Service Bulletin

S.B. No: 170

Title: INSPECTION OF CONTROL COLUMN AILERON STOP BOLT, MOUNTING PLATE AND RIVNUT

Applicability: T67A, T67B, T67C, T67M, T67M-MkII, T67M200, T67M260 and T67M260-T3A

FIGURE 1

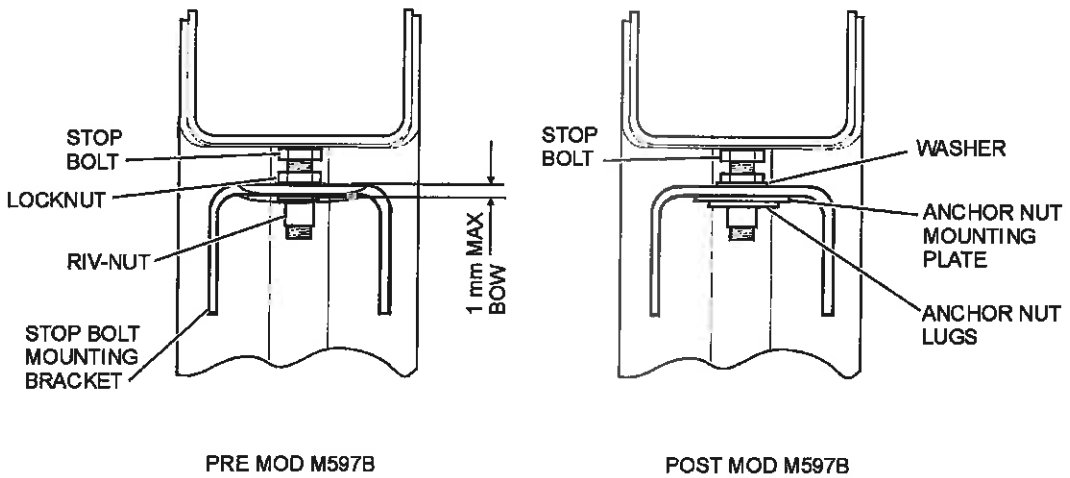
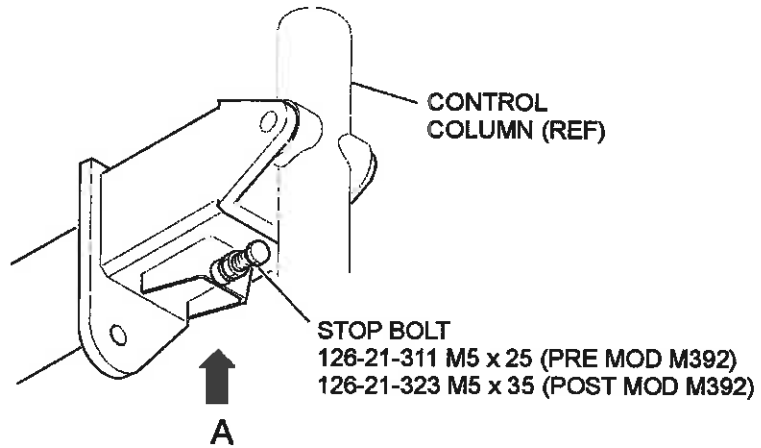
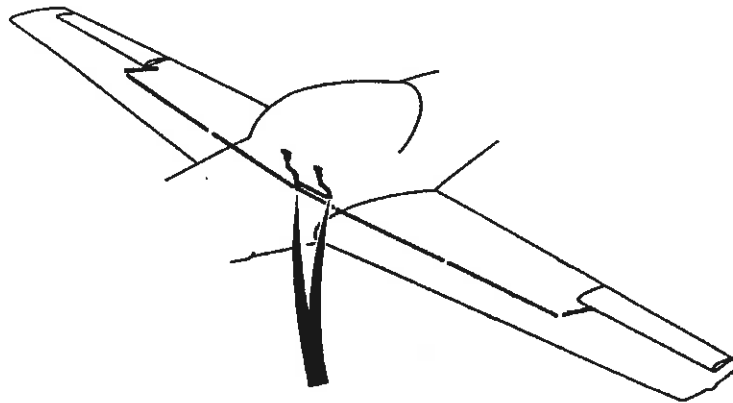
1. Check master switch, ignition switch and fuel are OFF. Disconnect external power and hangar aircraft if required.
2. Gain access to the base of the control column and to each aileron stop mounting position.
3. Inspect the stop bolt and its mounting for:
 - a, On Post Mod M392 aircraft: incorrect length of bolt. Bolt should measure, from under head, 35mm, (Pre Mod length is 25mm).
If bolt on a Post Mod M392 aircraft measures 25mm replace with bolt SAL stores code 126-21-323.
 - b. On Pre Mod M597B aircraft: i) bowing and ii) loose rivnut.
If mounting is bowed greater than 1mm – ref. Fig 1 Pre Mod M597B – and/or rivnut is loose. Invoke repair scheme to SAL DOI T67C-114 Post Mod M597A.
Post Mod M597B aircraft: i) loose locknut, ii) thin washer (.8mm thick) and iii) deformed or broken anchor nut lugs. See Figure 1 Post Mod M597B..

If loose locknut found, check washer is not bowed. If washer is bowed, replace with SAL Part No T67G-03-545.

If thin washer fitted replace with washer T67G-03-545.

If deformed or broken anchor nut lugs found then re-invoke repair T67C-114 issue 3 or subsequent.
